NUREG-1960

Safety Evaluation Report

Related to the License Renewal of Prairie Island Nuclear Generating Plant Units 1 and 2

Docket Nos. 50-282 and 50-306

Figure 4.3-1

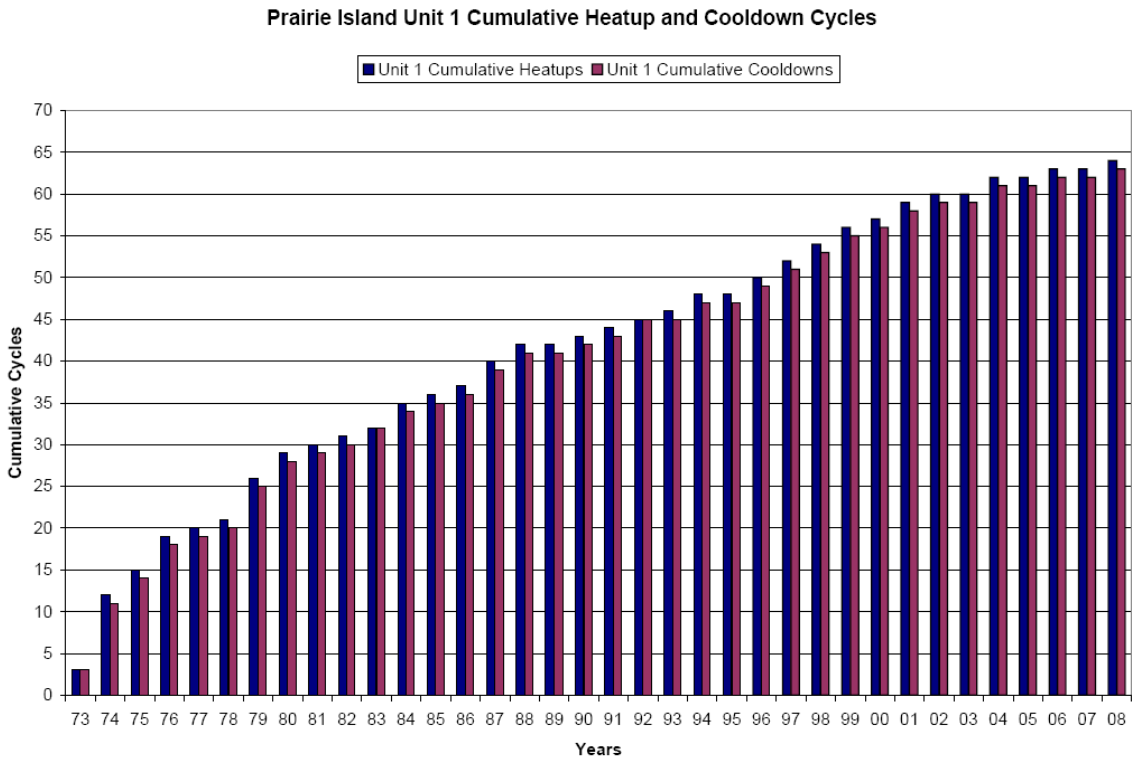
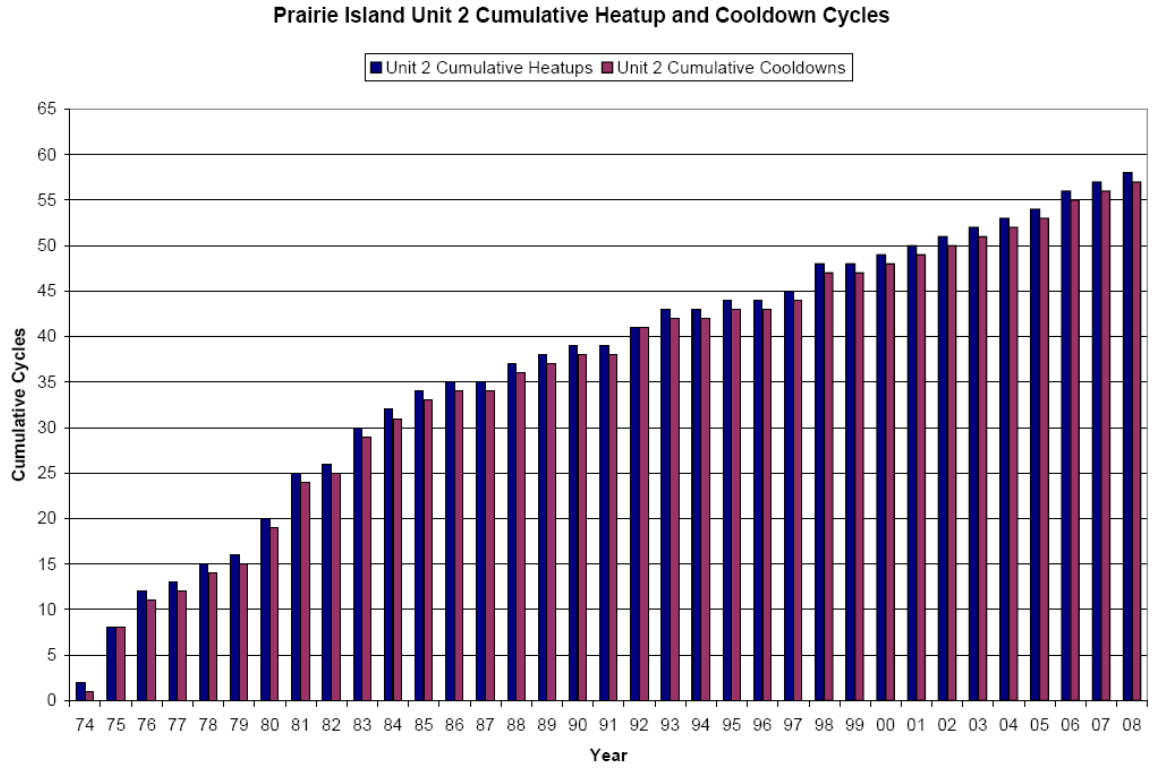
4.3-2, that the slope used by the applicant for making cycle projections is significantly greater than that of the average of the past 25 years. As expected, the slopes of event occurrence (i.e., the rates) during the first few years (5 to 7 years) are higher than the averages for both heatups and cooldowns. This means that the basis of projections that the applicant used is conservative and therefore, the staff found it to be acceptable.

Based on its review, the staff’s concern on the transient event monitoring is resolved because the applicant provided the information requested and the information validates the PINGP fatigue management program and the applicant's assumption for the number and severity of transients.
